This page transmits a revision to Alert Service Bulletin HC-ASB-61-332.

- Original Issue, dated Aug 17/11
- Revision 1, dated Dec 13/11

## HARTZELL PROPELLER INC. ALERT SERVICE BULLETIN TRANSMITTAL SHEET

HC-ASB-61-332 Propeller - Spinner Assembly

Example Portion of the Retired Spinner Dome Figure 6

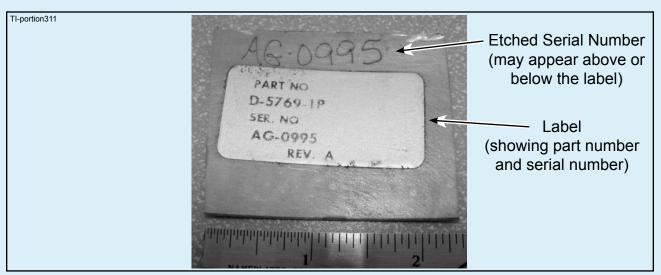
- 2) These retired components must not be modified or returned to service for use in any application including experimental applications.
  - These retired components must have a portion of the component cut out to include the part number and serial number. Refer to Figure 6. This portion must be returned to Hartzell Product Support.

- b) These retired components must not be modified or returned to service for use in any application including experimental applications.
        - c) These retired components must have a portion of the component cut out to include the part number and serial number. Refer to Figure 6. This portion must be returned to Hartzell Product Support.

C-4549-1(P) Metal Adapter Ring Figure 7

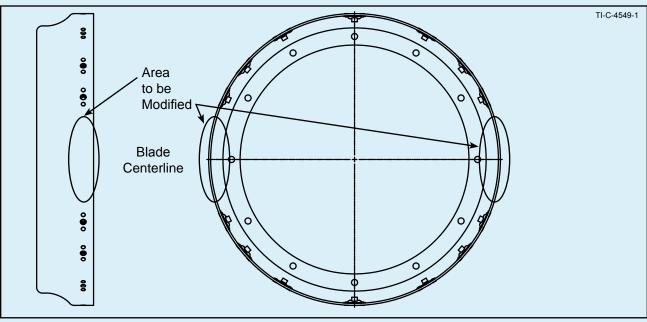
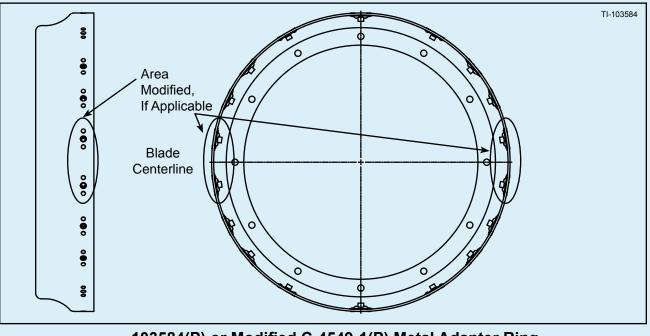
- (d) Hold one of the 103583() or 104001() composite filler plates in place, centered in one of the blade cut-out holes, flush with the bottom edge of the adapter ring, aligning the filler plate attachment holes with the row of assembly screws around the dome. Refer to Figure 7 and Figure 9.

- On the inside diameter of the C-4549-1(P) metal adapter ring, hold one (1) B-3849-3 floating nutplate so that the nutplate is oriented in the same direction as the other nutplates on the inner diameter of the adapter ring and the filler plate attachment hole is aligned with the other assembly holes and with the newly drilled hole. Refer to Figure 7, Figure 8, and Figure 9.

Figure 10

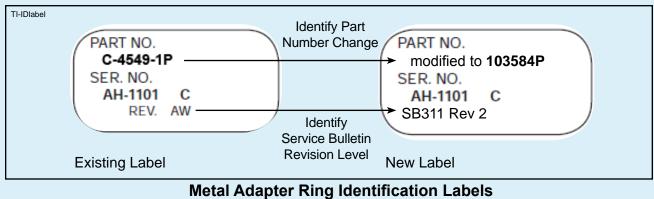
- 2 Type, print, or write on the label to provide the new, modified part number and the original serial number. Include the information as shown in Figure 10.
